Candice Assadzadeh, Senior Planner
City of Riverside
Community Economic Development Department – Planning Division
3900 Main Street, 3rd Floor
Riverside, CA 92522

DATE: SEPTEMBER 25, 2023
TO: SONYA HOOKER, RUTH VILLALOBOS & ASSOCIATES, INC.
FROM: CARLA WAKEMAN, L&L ENVIRONMENTAL, INC.
Subject: ALPINE MEADOWS RESPONSE TO COMMENTS

PLANNING CASE PR-2022-001293 (PM, GE): Proposal by Jerardo Reyes and Ryan Williams to consider the following entitlements: 1) Tentative Parcel Map (No. 39174) to subdivide a 5.74-acre parcel into four parcels for residential purposes; and 2) Grading Exception to allow grading within the Prenda Arroyo and the 50-foot arroyo setback. The Planning Division of the Community & Economic Development Department recommends the Community & Economic Development Director determine the project will not have a significant effect on the environment and adopt the Mitigated Negative Declaration and Mitigation Monitoring and Reporting Program (MMRP).

Figure 4
Mapped Area of
Prenda Arroyo
 (Riverside, California Code of Ordinances / Title 17
https://library.municode.com/ca/riverside/codes/code_of_ordinances)
 Alpine Meadows Lane, City of Riverside
 County of Riverside, California

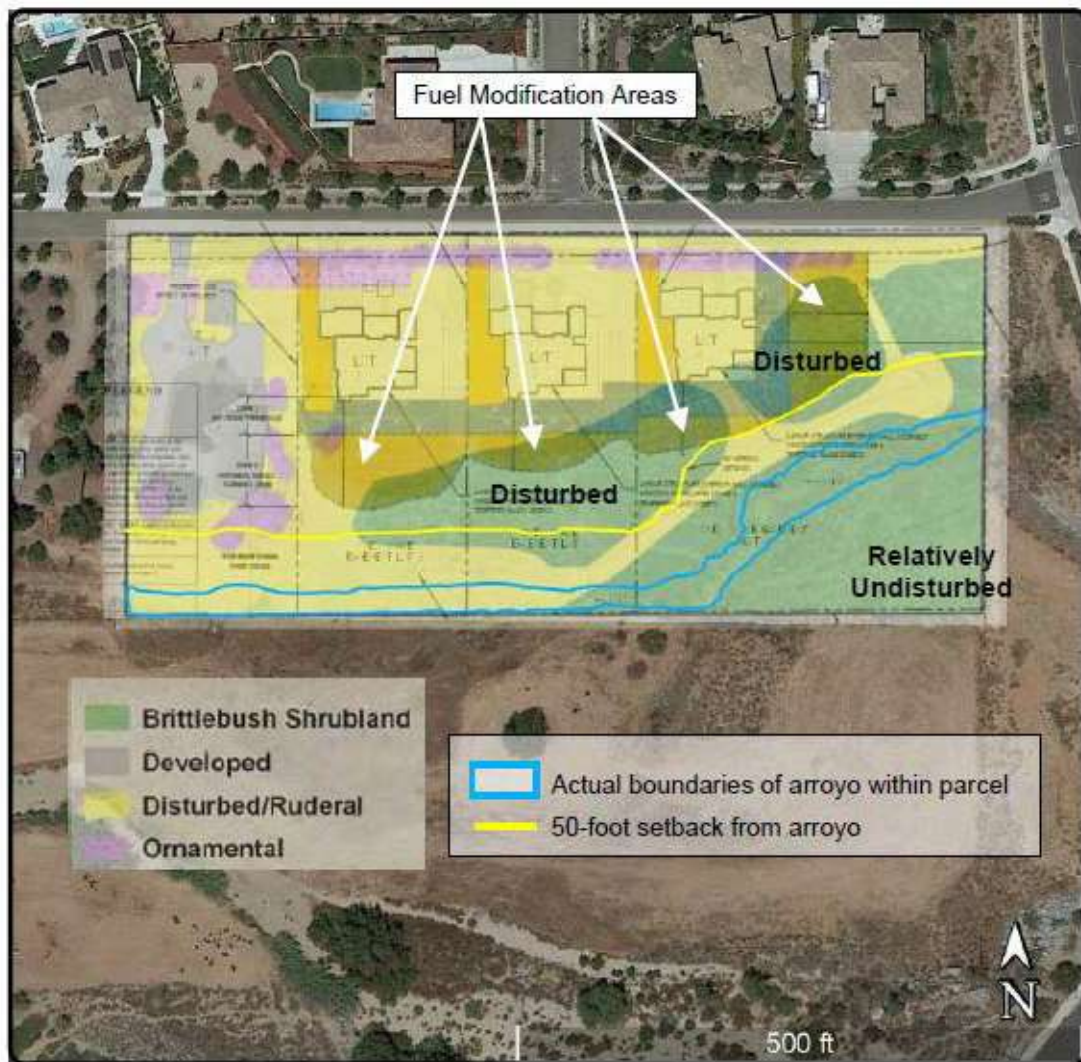
Comment: “Friends of Riverside’s Hills is very concerned about protecting the City’s designated arroyos, very much including the Prenda Arroyo. The Initial Study for the project says “The project site is largely within the mapped extent of the Prenda Arroyo, as identified in the Riverside Municipal Code (RMC), Title 17 Grading, Exhibits A-F, and is therefore subject to the requirements of the Hillside/Arroyo Grading Ordinance.” Actually examination of said Exhibit C appears to show that the project site is all or mostly all entirely well within the mapped portion of the Prenda Arroyo....

Comment: “That means that any consideration of conformity with the Code’s Hillside/Arroyo provisions, by the developer’s consultants or the City Planning Division, may well have ignored the fact that the disturbed area is within the Prenda Arroyo, and thus have been inadequate.”

Comment: “The City’s Grading Code, section 17.28.020 Hillside/Arroyo Grading, includes the following provisions:

The project map in the Biological Resources Assessment and the City map of the Prenda Arroyo (Exhibit C) in the Grading Code taken together show that the entire proposed developed area (graded area and buildings) is within the main Prenda Arroyo itself and not within the arroyo tributary coming from the northeast (which crosses into the project site but not the proposed developed area of that site) nor any other arroyo tributary. While the quoted code provision subsection a. allows the Director to administratively allow grading within an arroyo tributary, it gives no such authority regarding grading within the actual arroyo (as opposed to grading within a tributary). Thus this project is in several ways in violation of the above quoted grading code provisions 14 a, d, and e. Since these provisions are obviously environmentally purposed, the Initial Study gave the wrong answer to question 11b about conflict with such provisions, and as we previously noted, under CEQA the project requires an EIR rather than an MND.”

“As shown in Figure 4, most of the parcel is within the mapped extent of the Prenda Arroyo except for a portion of the northeast quadrant and a small area of the southeast corner.”

Although the project site is within the mapped Prenda Arroyo per RMC Title 17 Exhibit C, it is not within the actual Prenda Arroyo, which is based on in-person assessment of the site and documentation of the current conditions of the site by an experienced biologist. (emphasis added)

As outlined in the responses above, the project does not conflict with the provisions of RMC Title 17 Grading, 14. a-d. As further outlined in the *Western Riverside County Multiple Species Habitat Conservation Plan Consistency Analysis*, Figure 7b (page 25), the actual boundaries of the arroyo within the project parcel are shown in blue, and a 50-foot setback, which are both located outside of the development footprint, the grading limits, and the fuel modification areas of the project, showing complete avoidance of the actual arroyo.
